# **Wellington City Proposed District Plan**

## **Hearing Stream 7 - Tertiary Education Zone**

### **Section 42A of the Resource Management Act**

**Part 3 – Special Purpose Tertiary Education Zone**

**Figure 7: Existing building heights**

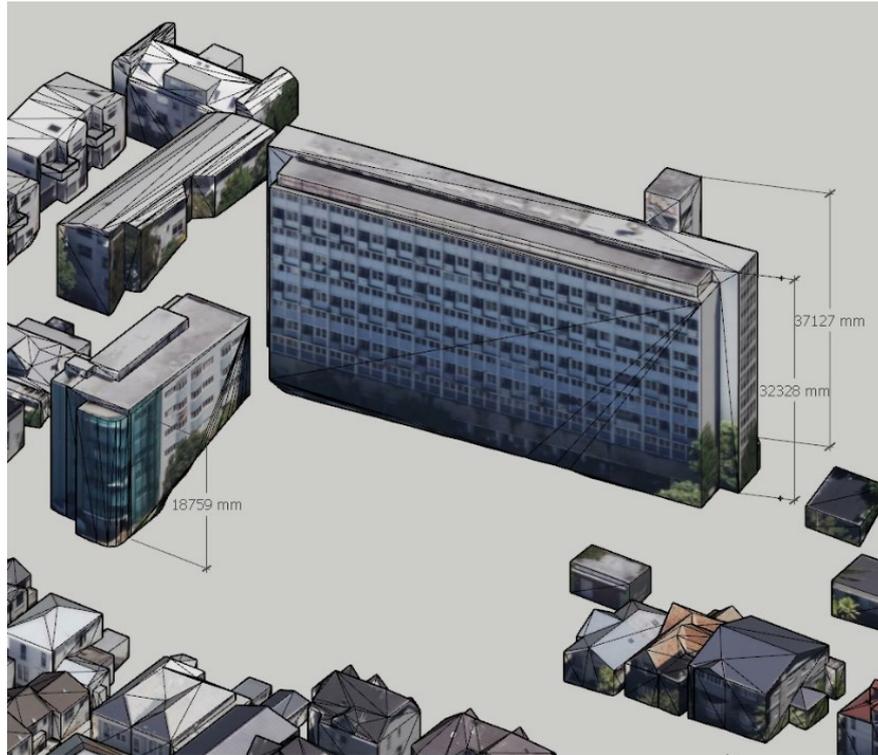
- ii. 106.25 – This submission point seeks that Height Control Area 2 (34 metres) is applied to the Te Huanui Project area that is within Height Control Area 4 (21 metres) and is located more than 20 metres from a residential boundary. As shown at Figure 7 below, the existing Gordon Wilson Flats building is 7-10 storeys high, and approximately 32.33 metres in height (with a maximum 37.13 metres at the top of the lift overrun on the western elevation). McLean Flats is 18.76 metres high.

**Figure 8: Portion of 320 The Terrace located 20m from a residential boundary**

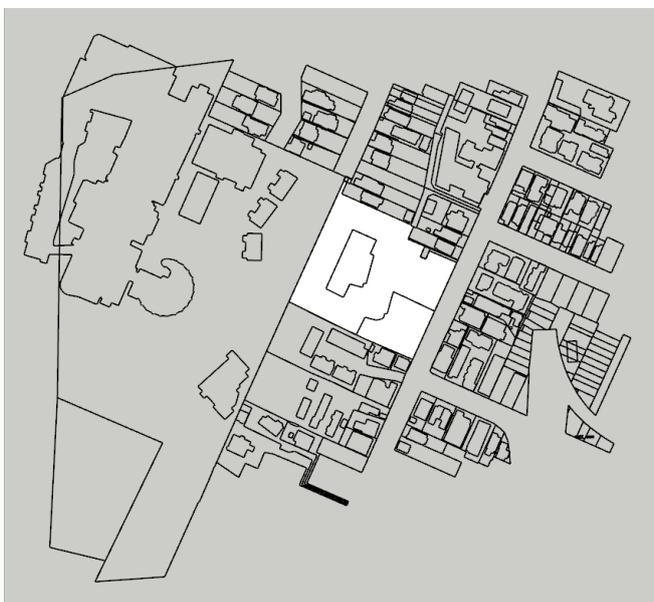
This option would allow for approximately 1.7 metres of additional building height in comparison to the height of the existing Gordon Wilson Flats buildings, albeit in a more central location at 320 The Terrace than where this is currently located. Note that the remainder (ie periphery) of the site could be developed up to 21 metres in height, subject to meeting the boundary setback controls at TEDZ-S3 and the restrictions on building on the escarpment as set out at TEDZ-S4 (where development on the escarpment is restricted to 35%<sup>22</sup>).

**Figure 10: Building envelope at 34m height**

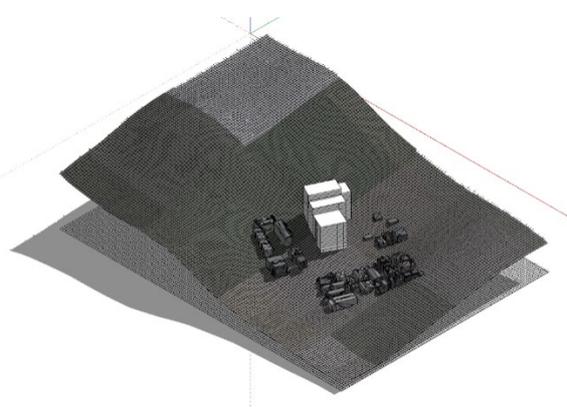
This change would provide the submitter with significantly more development potential if 320A The Terrace is rezoned as TEDZ. Combined with the rezoning, this change could result in one or more buildings across 320 and 320A The Terrace being constructed up to 34 metres in height with the centre of the TEDZ site(s). It is noted that building height is measured from the existing ground level underneath the building. As shown in the image on the right in Figure 10, the additional height could follow the contour of the site, and result in the rear (western) part of the building appearing taller. Again, it is noted that TEDZ-S4 restricts development of the escarpment at the rear of 320 The Terrace.
